## FIELD SAFETY NOTICE / PRODUCT NOTIFICATION

**Subject:** Fixation of iMRI Registration Matrix for GE might not be rigid, potentially affecting the accuracy displayed in the navigation.

**Product Reference:** iMRI Registration Matrix for GE

**Brainlab Identifier:** CAPA-20150821-001476

Figure 1: Brainlab iMRI Registration Matrix for GE

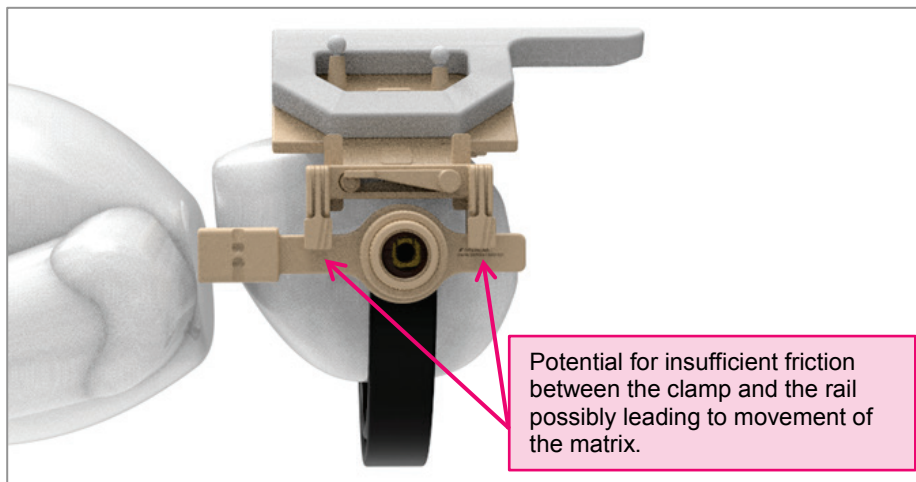
It has been detected that the fixation between Registration Matrix and Rail Adapters (see *Figure 1*) may not always prevent slipping.

The friction between the rail clamps and the rails, without the necessary caution, may not always secure the device in its intended position, when high forces are applied on the Registration Matrix. This could be the case, among other possible scenarios,

As a result, movement of the Registration Matrix (containing the MR and infrared markers required for navigation) relative to the GE Skull Clamp, and thus to the patient's head, might occur.

1. Existing potentially affected customers receive this product notification letter.
2. Brainlab will provide revised hardware to affected customers in order to resolve this issue for the *iMRI Registration Matrix for GE* after availability.  
Brainlab will actively contact you starting January 2016 to schedule the exchange of hardware.
